City of Richmond
Planning and Development Department

Report to Development Permit Panel

To: Development Permit Panel
From: Wayne Craig
Acting Director of Development
Date: August 21, 2007
File: DP 07-363084
Re: Application by Tussy Berg, Markus Berg and Viktor Berg of
H.A. Berg Investments Ltd. for a Development Permit at 11991 No. 1 Road
(formerly 11991 No. 1 Road and 3911/3931 Chatham Street)

NORTH CLANED ELEVATION
 SCALE: 3/8" = 1'-0"

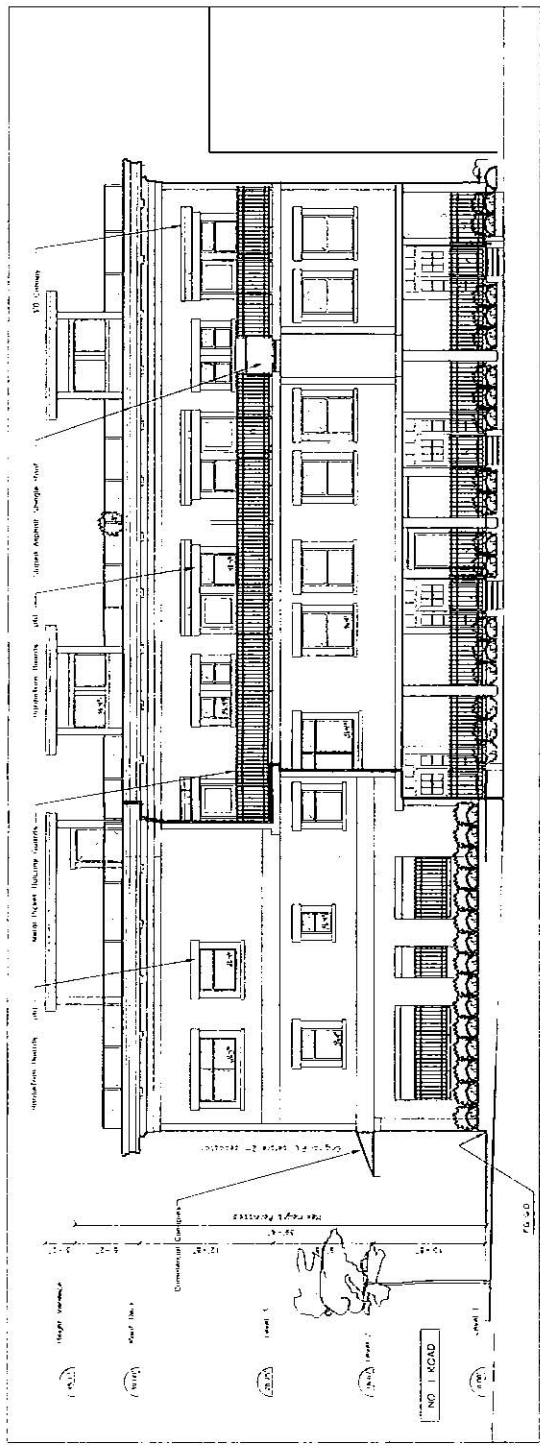
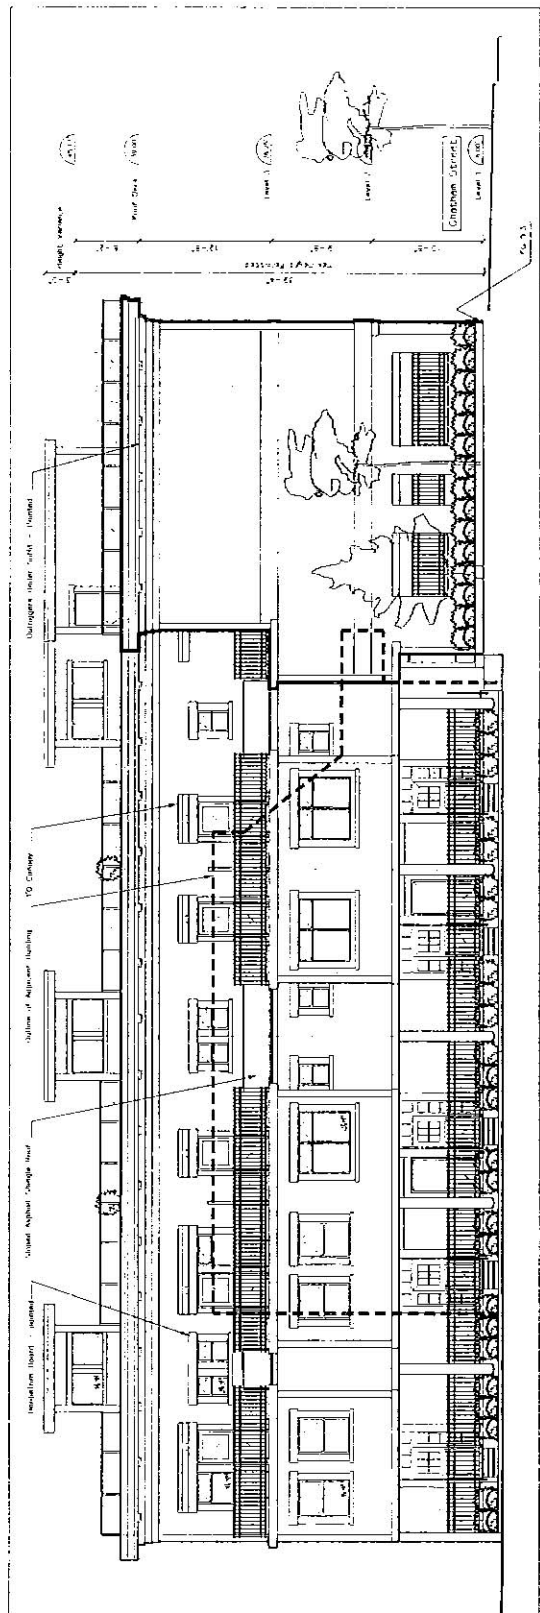
8. Consider controlled access for the entry court off of the parking – *Incorporated.*
9. Consider design development for the north lane elevation visible from No. 1 Road – *Incorporated.*

Sketch of Juliet Balcony and Awning Junction

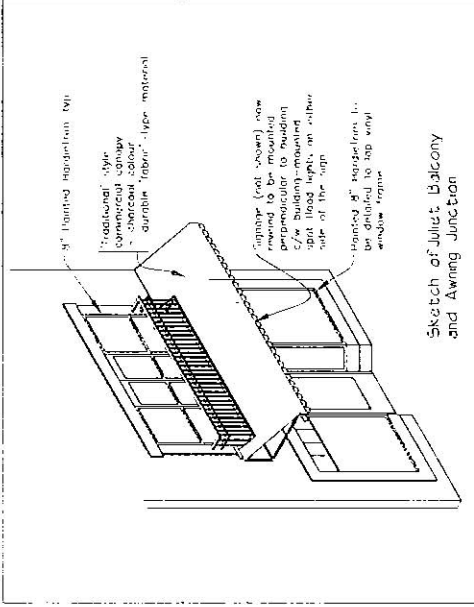
6. Consider the colour choice of the canopies for maintenance – *Dark colour chosen as recommended by manufacturer.*
7. Consider the intersection of the canopies and railings – *Detail provided.*
